3000 Pearl Concept Plan Review

City Council. January 15, 2015

Concept Plan Review Purpose (§9-2-13 B.R.C. 1981)

Initial Concept Plan Comments

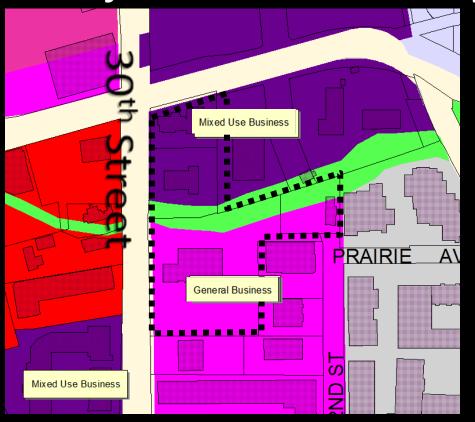
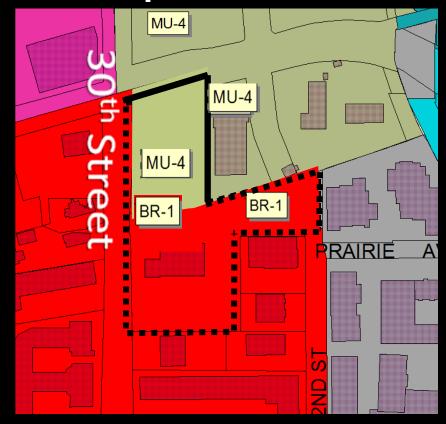
- There was interest in seeing the ditch function as an amenity for residents and retail spaces.
- Include family friendly and other unit types
- Consider including family friendly amenities such as playgrounds and daycare.
- There was general interest in varying the heights of buildings. They should not be monolithic.

- The proposal generally meets the TVAP and BVRC but a monolithic height would not be acceptable.
- Consider keeping the Quonset hut as a possible amenity.
